PRJ-26-000510887

**“ OEM Tableland SPC Other 48V
STUBBING Short Term Solution SUS
”**

Name of the project (Type of change)

Tesla request to install service cavity Plugs on Connectors

BEFORE AND AFTER COMPARISON

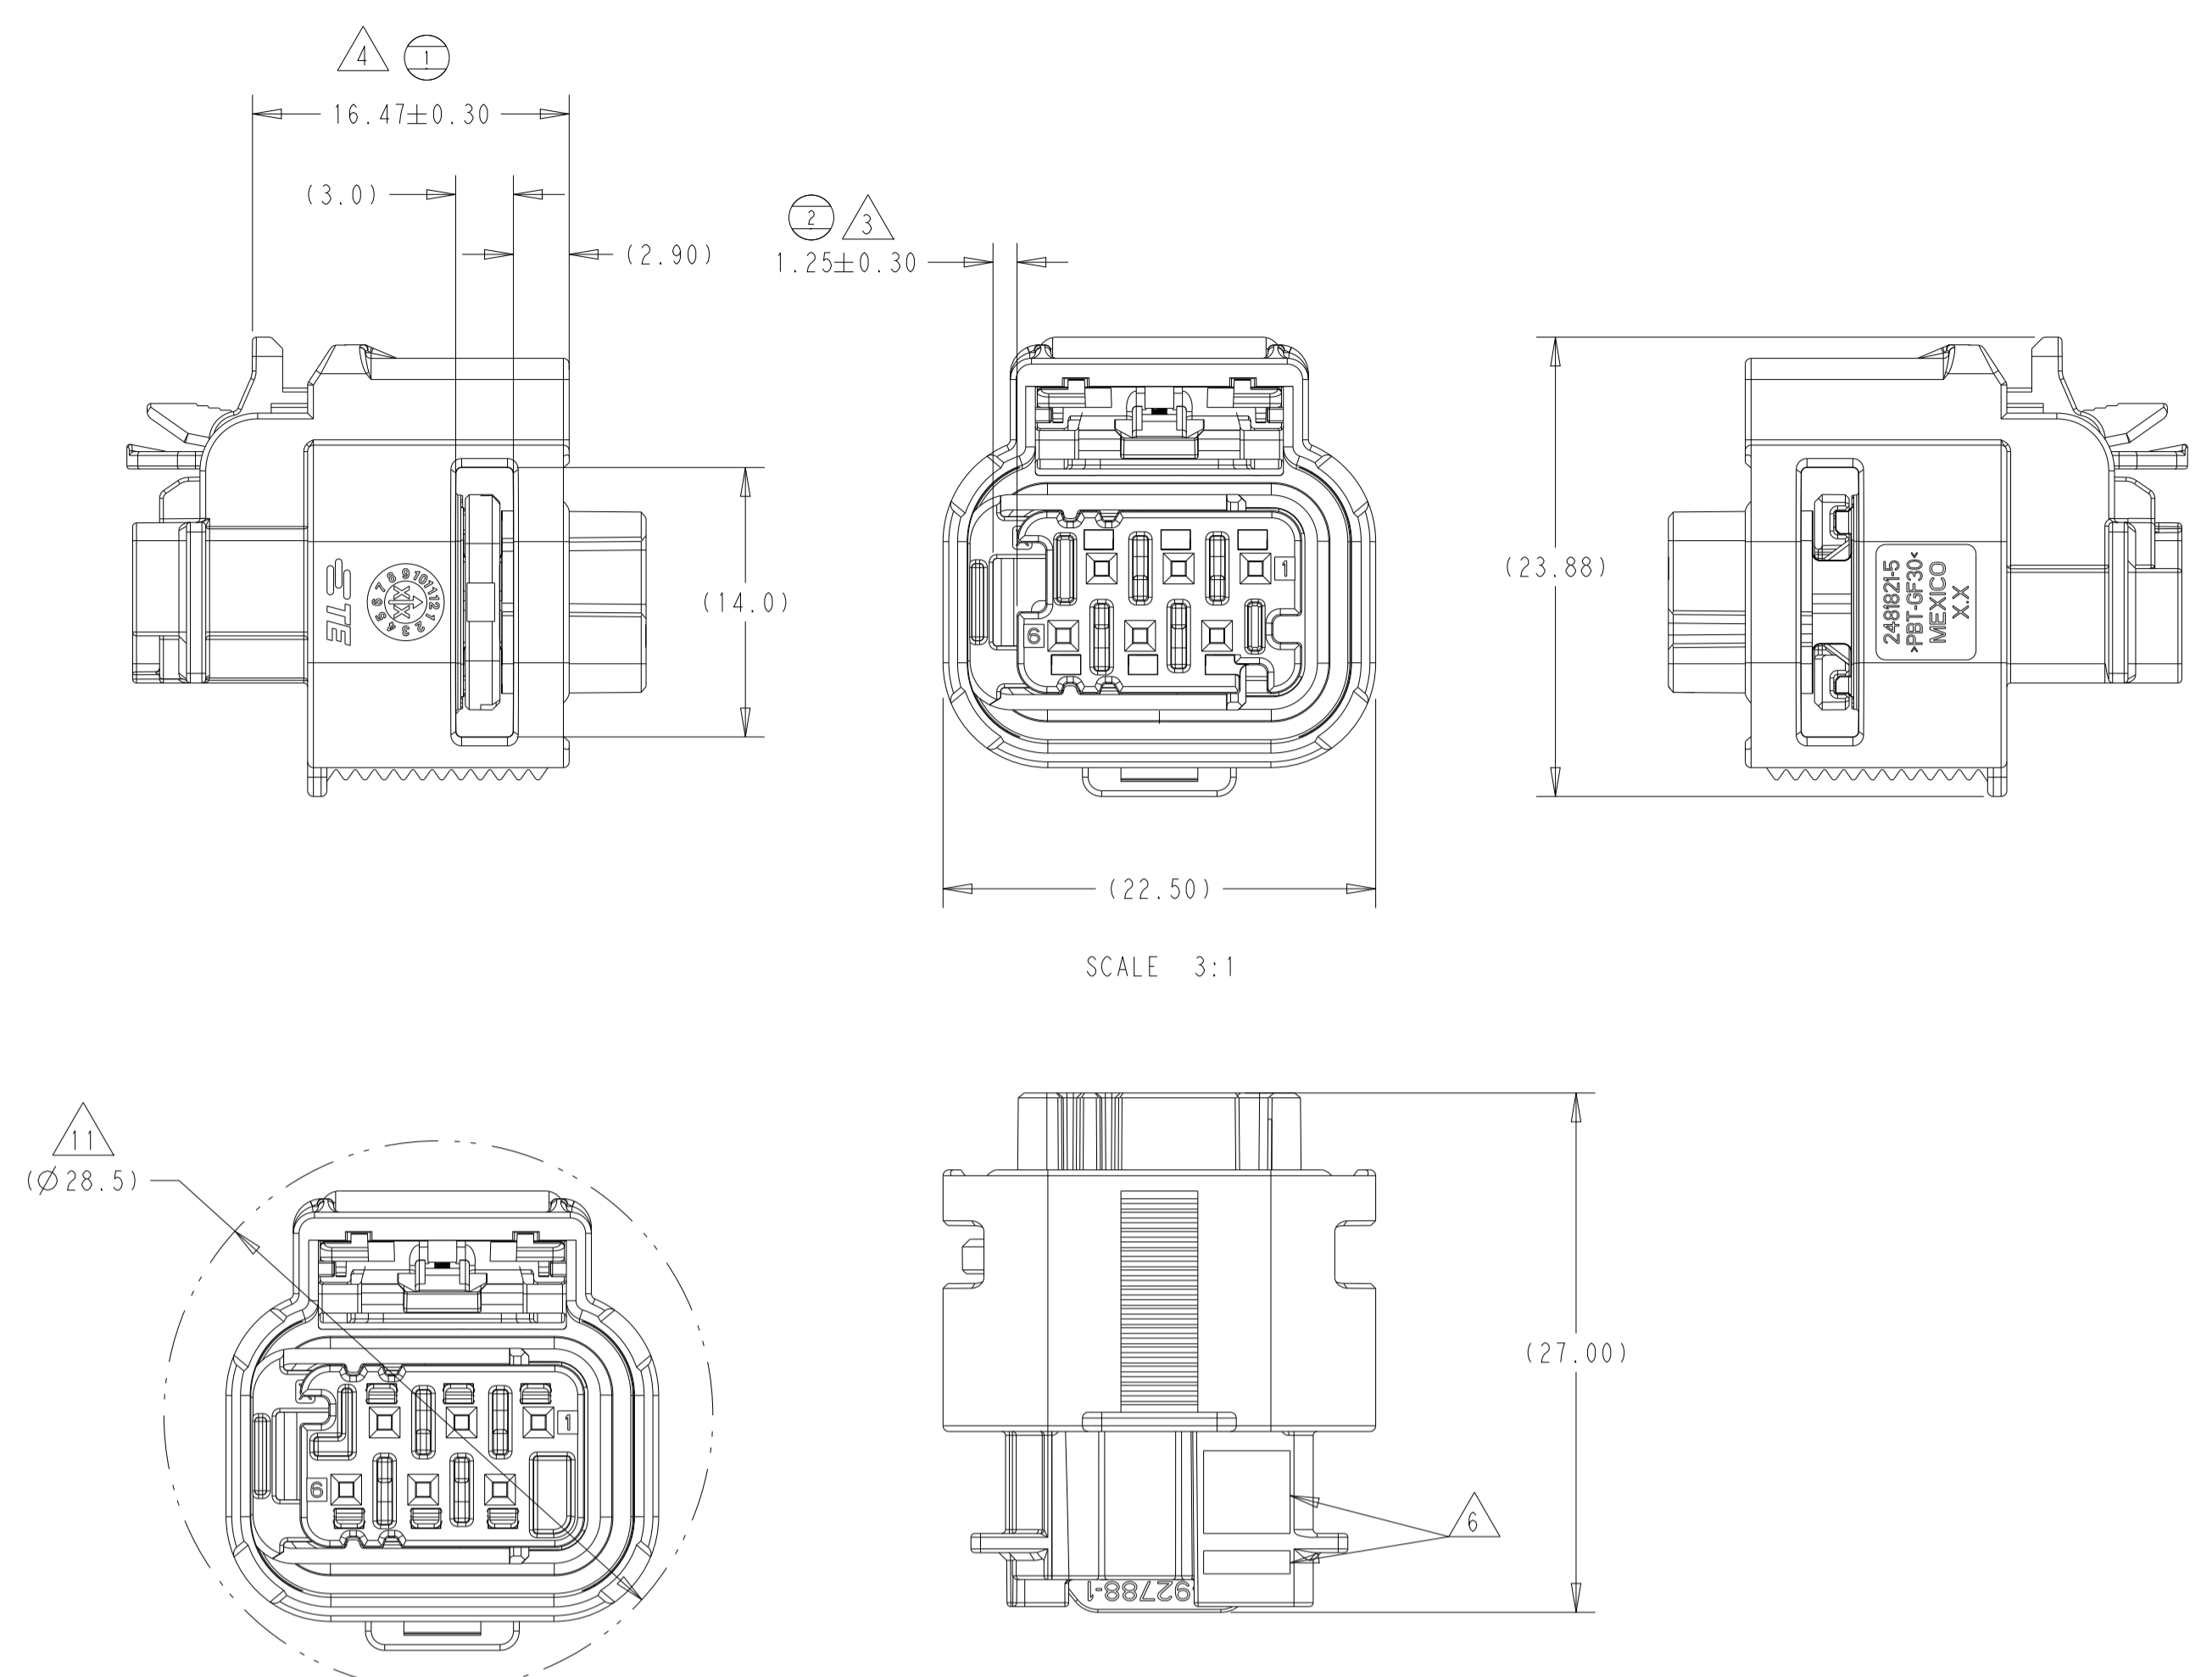
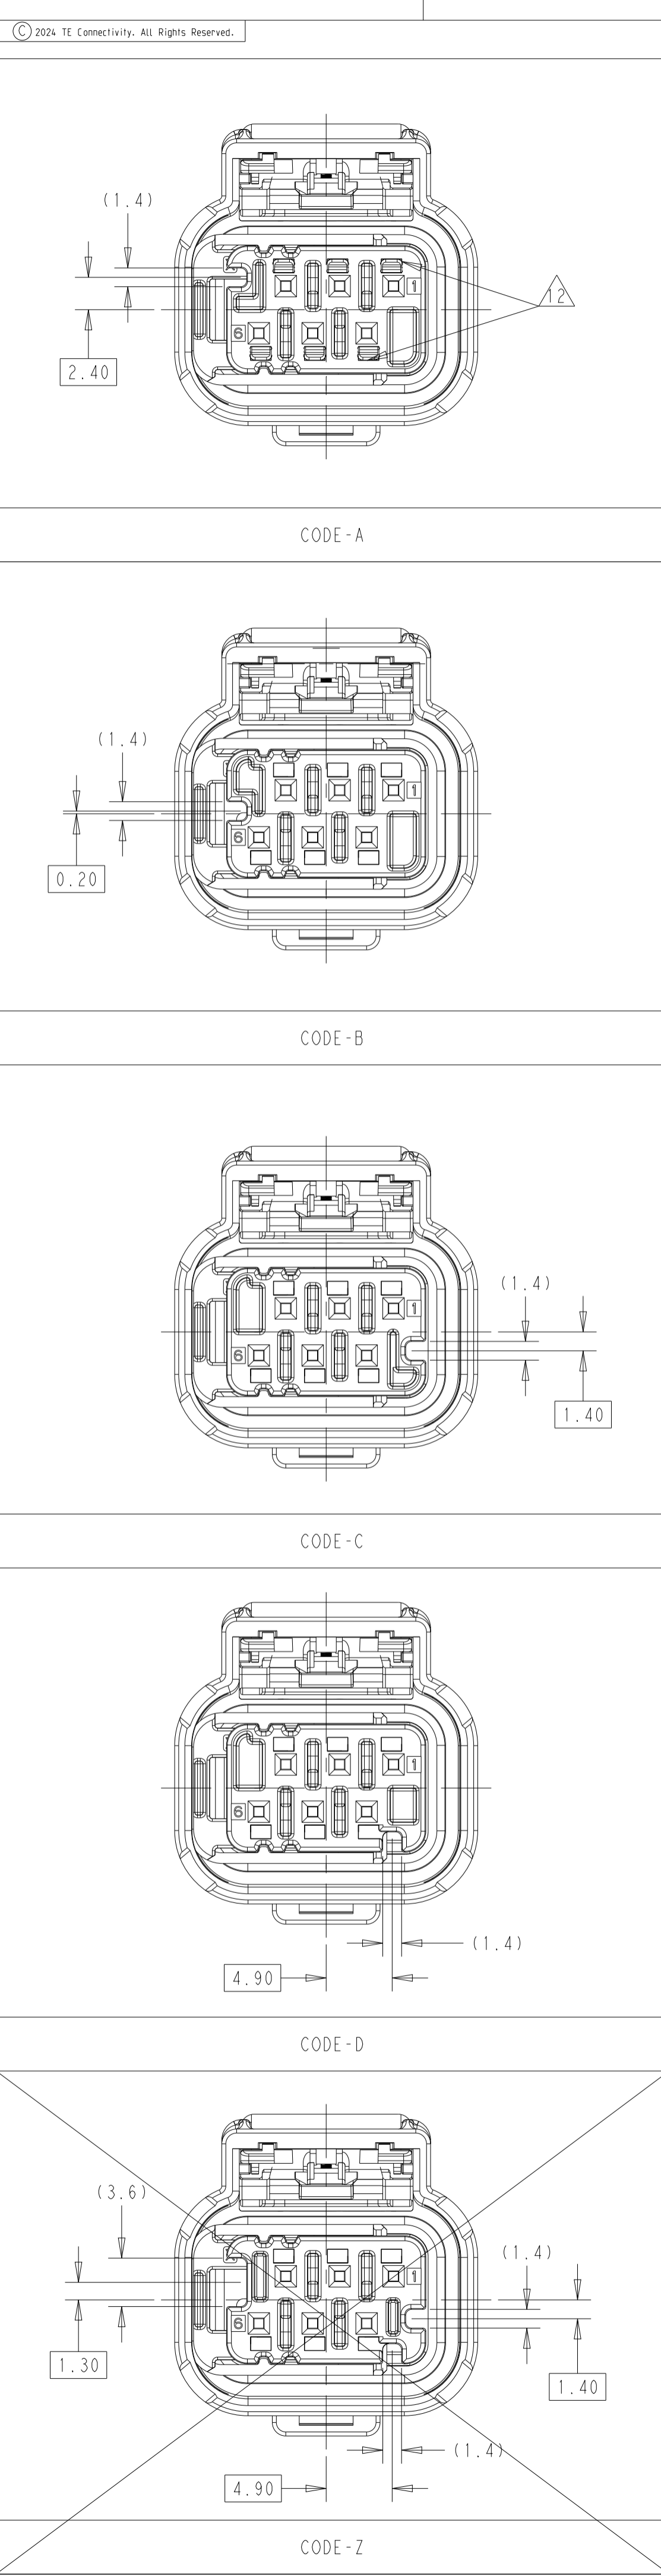
- 2482235-2.....18P LP Female
- 2479034-2.....28P LP Female
- 2476961-1.....6P LP Female
- 1-2476961-1....6P LP Female
- 2482265-1.....18P LP Female
- 2479034-1.....28P LP Female

Molded Connectors will now have Plugs inserted on Service Cavities.

TE TE Connectivity
 NAME: 6POS,MOS,REC HSG ASSY,SLD
 SIZE: 408-18056
 CAGE CODE: 00779
 DRAWING NO: 2476961
 RESTRICTED TO: TSLA

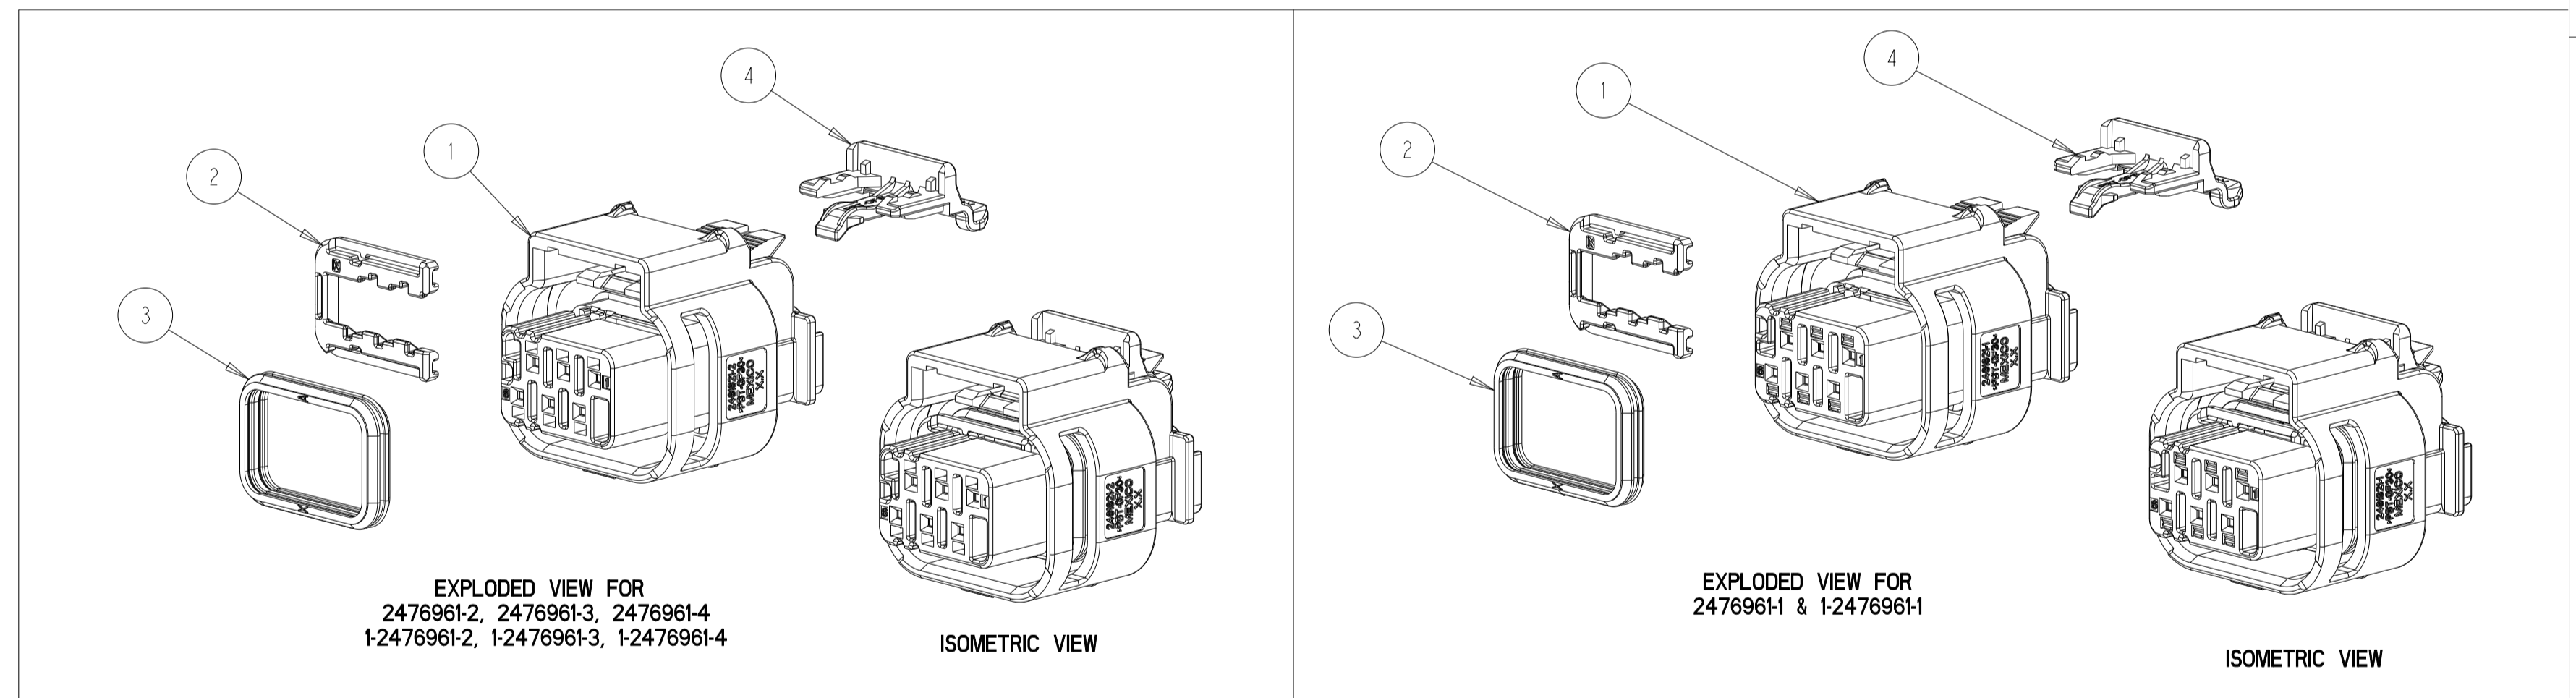
- THIS PRODUCT HAS NOT COMPLETED VALIDATION TESTING.
- FOR CONNECTOR HANDLING AND USE INSTRUCTIONS, REFERENCE TE SPECIFICATION NUMBER: 408-18056
- MINIMUM PASS-THROUGH CONDITION WITH 1.0mm CLEARANCE ALL AROUND.
- 2561506-1 CAVITY PLUG USED ON 2476961-1 & 1-2476961-1 ASSEMBLY
- PRELIMINARY- NOT RELEASED FOR PRODUCTION.
